Variante (se aplicável): <b>[No Variations]</b>			
Title			Organization
Size: <b>A4</b>			Country
Number: <b>1</b>			My Address
Revision: <b>V.1.2</b>			My State
Date: <b>2025-08-25</b>	Time: <b>11:41:03</b>	Sheet <b>1</b> of <b>1</b>	My Zip Code
File: <b>DONGLE02.SchDoc</b>

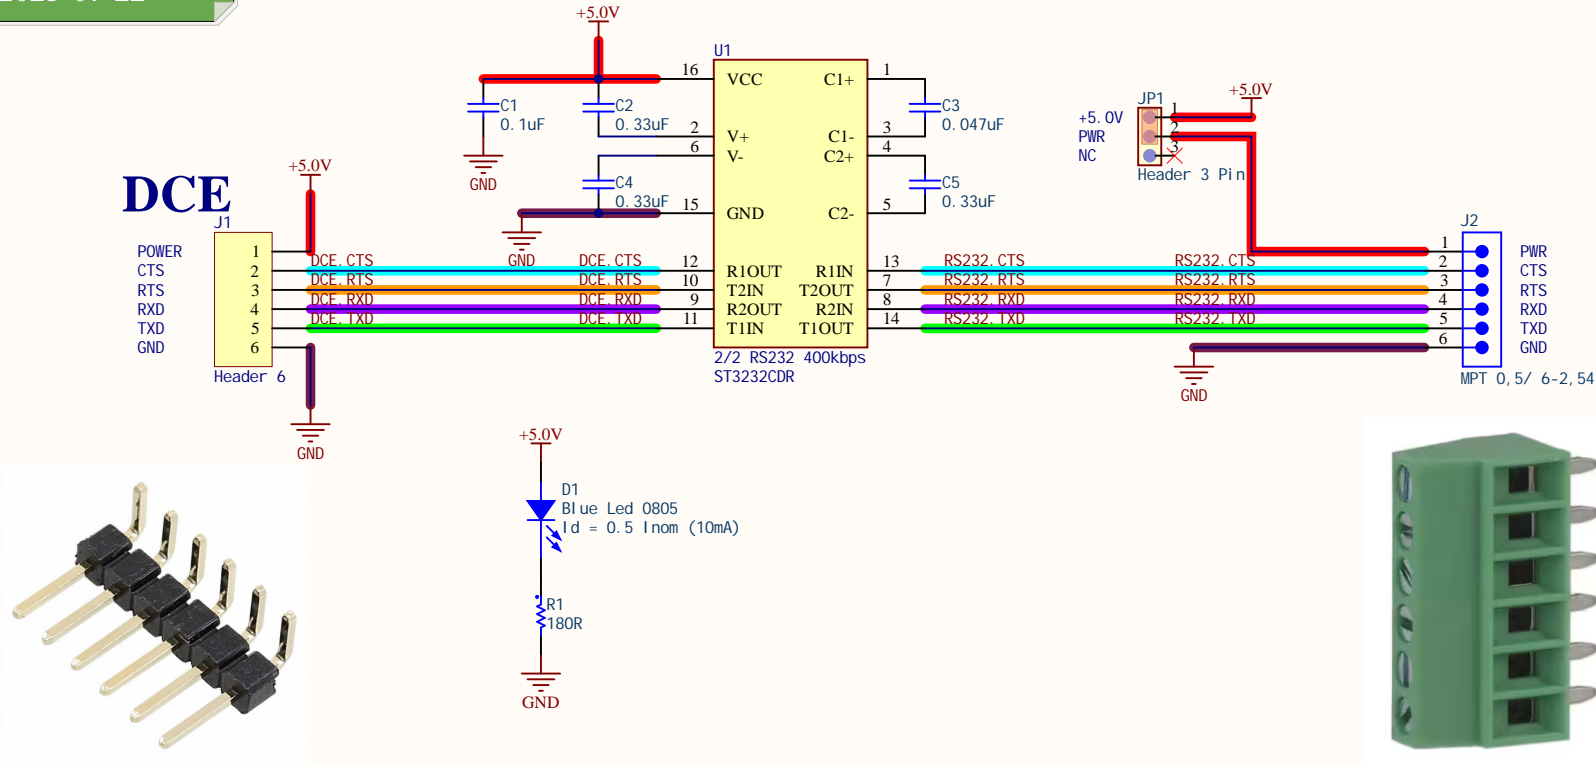
Bug detected: RX,TX,RTS and CTS need to be swaped. New version of PCB needed.

Bug Fixed at 2025-07-22
